ADDENDUM No. 3

PC26-023 CDBG-DR Hometown Revitalization Program – Truesdell Facility

June 26, 2026

SHEET NO.
A1.03

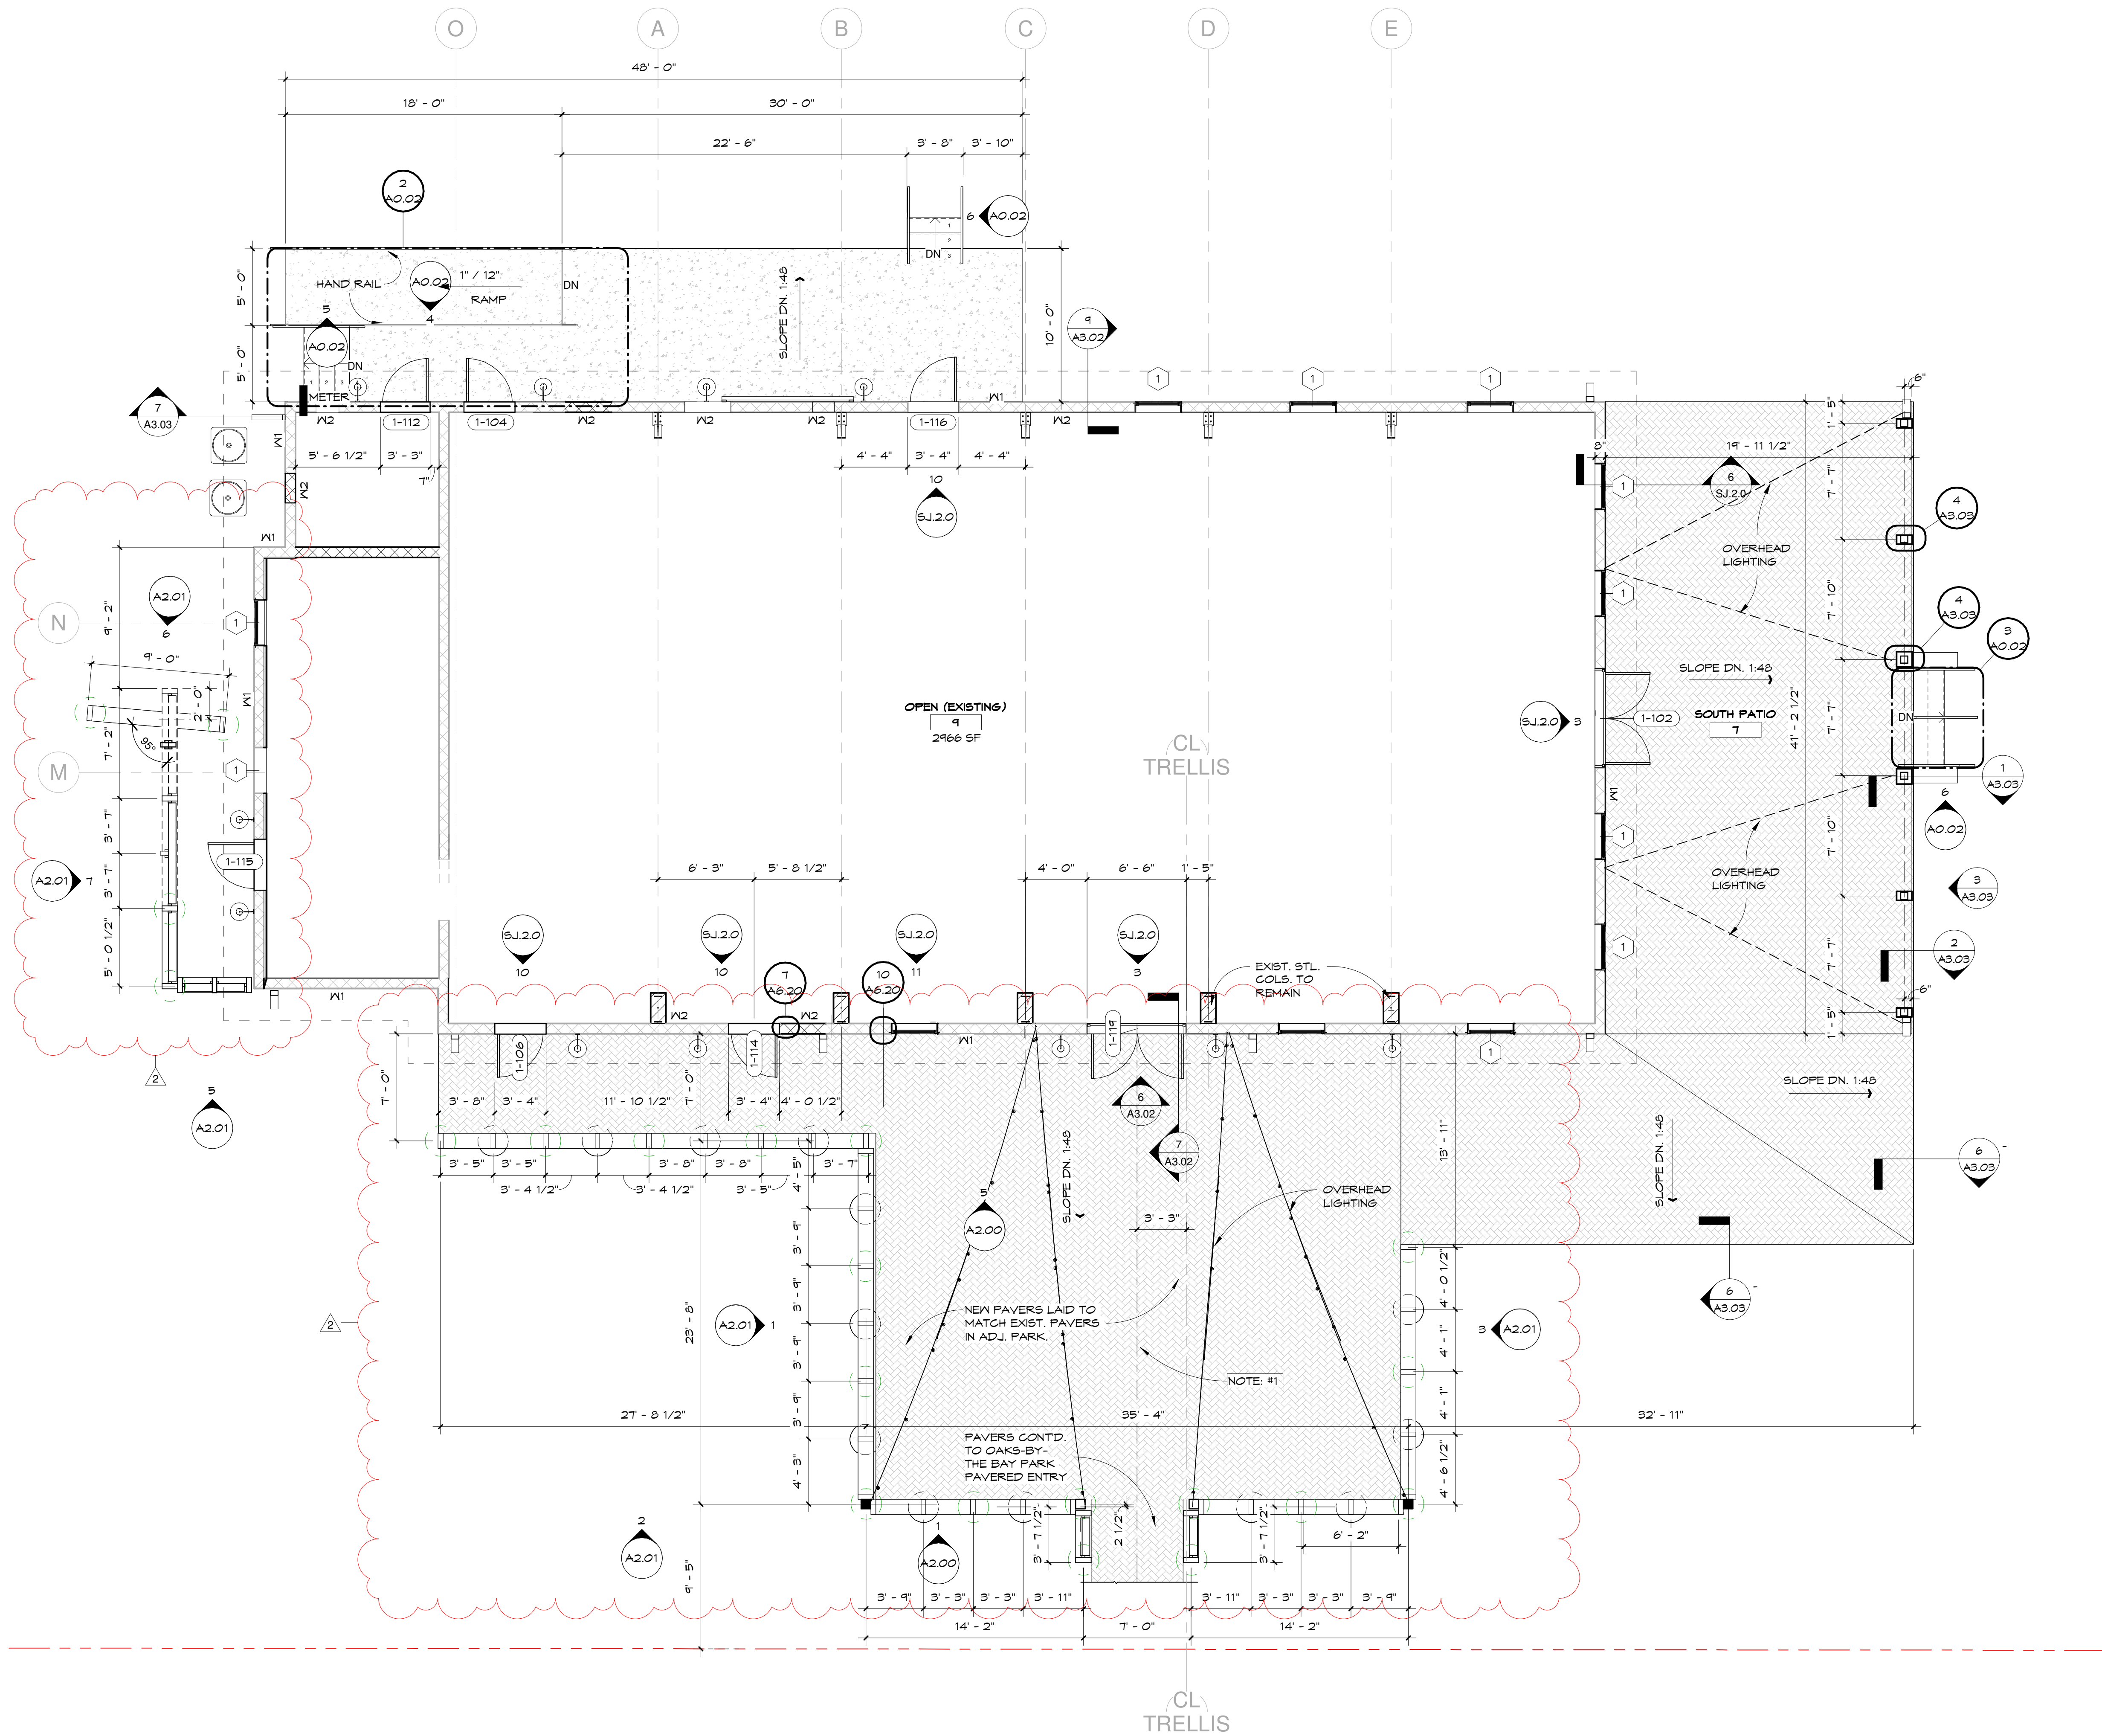
8. **RFI:** Demo key not 5 on A1.01A states the “existing interior building frame to be exposed”. Can we get clarification on the extent of this interior demo? Is it at the column conditions only along the exterior walls? Key note 5’s symbol is not on the demo plan detail.

RESPONSE: No interior demolition required; refer to drawing attached to this addendum for revised demolition schedule.

1
A2.00
NEW CONSTRUCTION - WEST ELEVATION
3/16" = 1'-0"

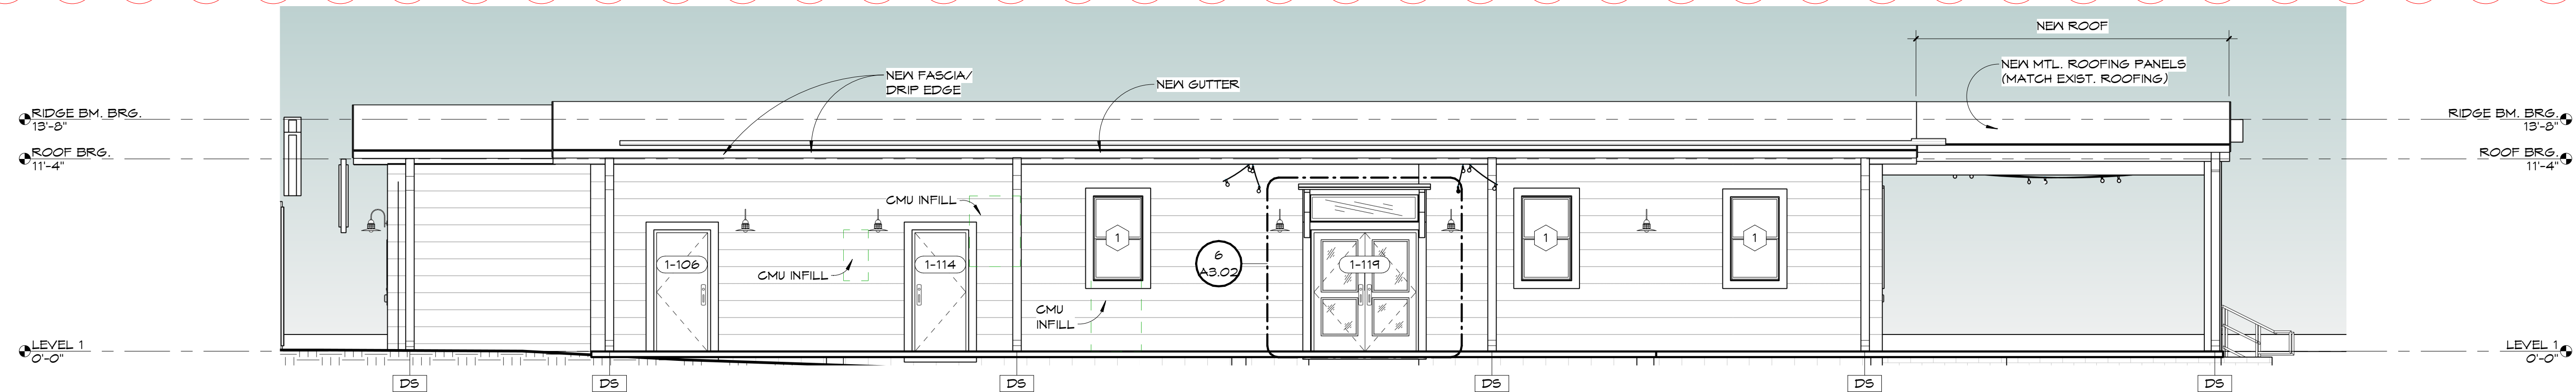
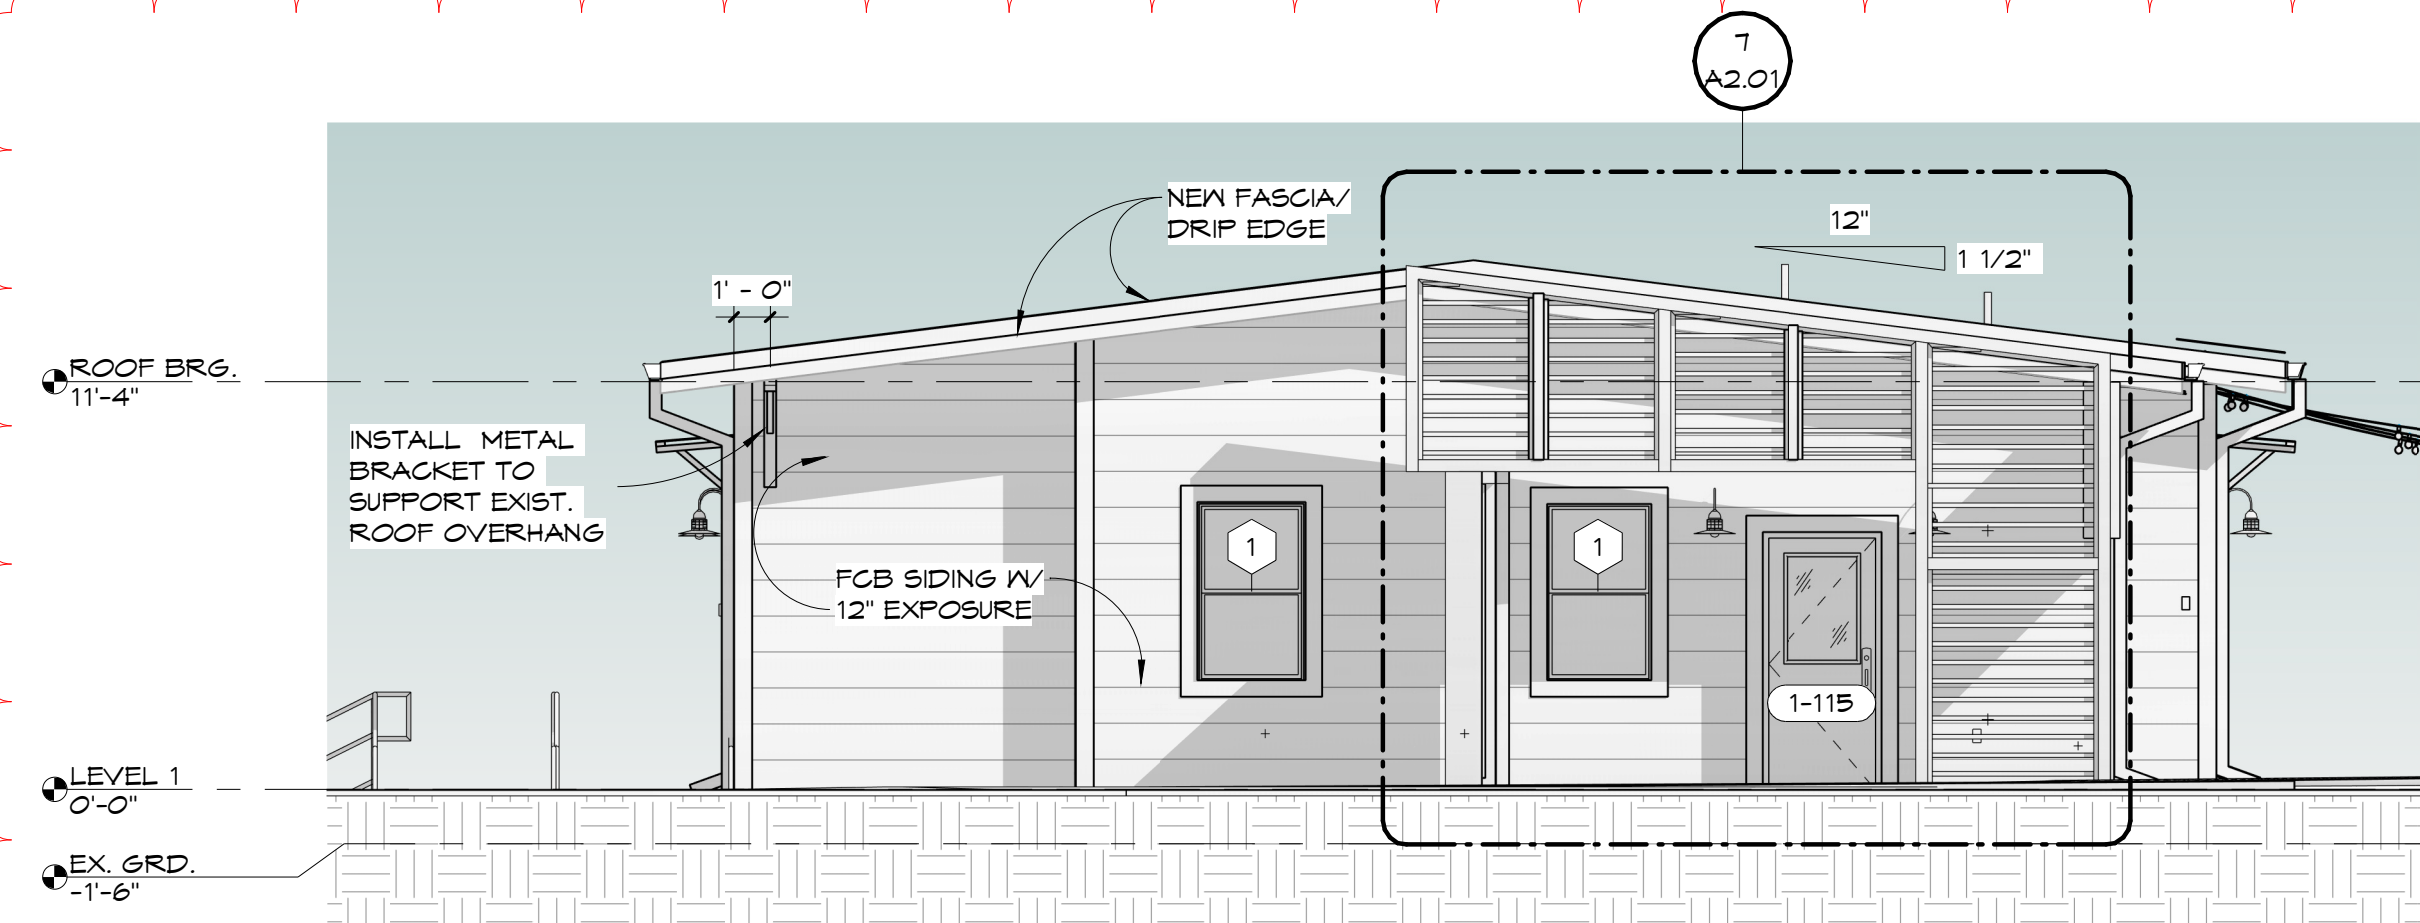
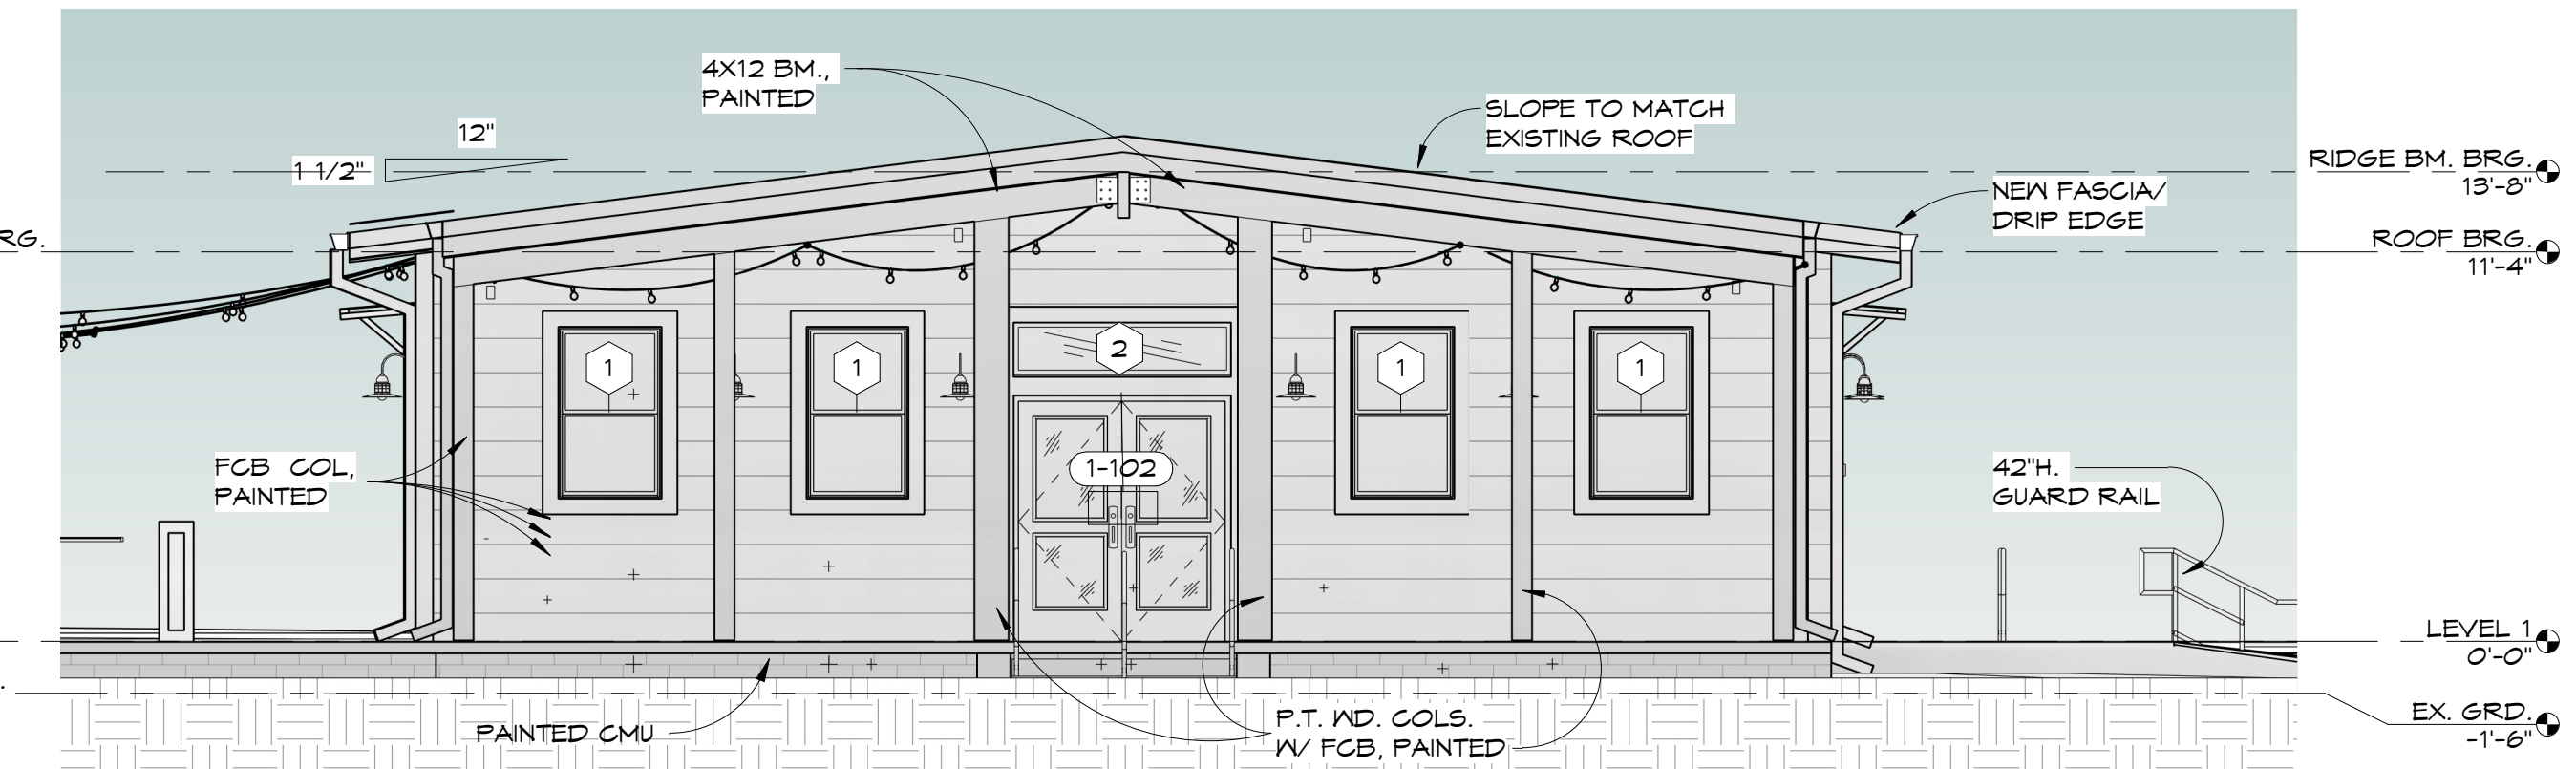
6. **RFI:** Do the privacy screens on the south and east elevations need additional intermediate post to prevent slat bowing?

RESPONSE: Intermediate posts and footings added to privacy screens; refer to drawings attached to this addendum for revisions to fencing and fence lighting.
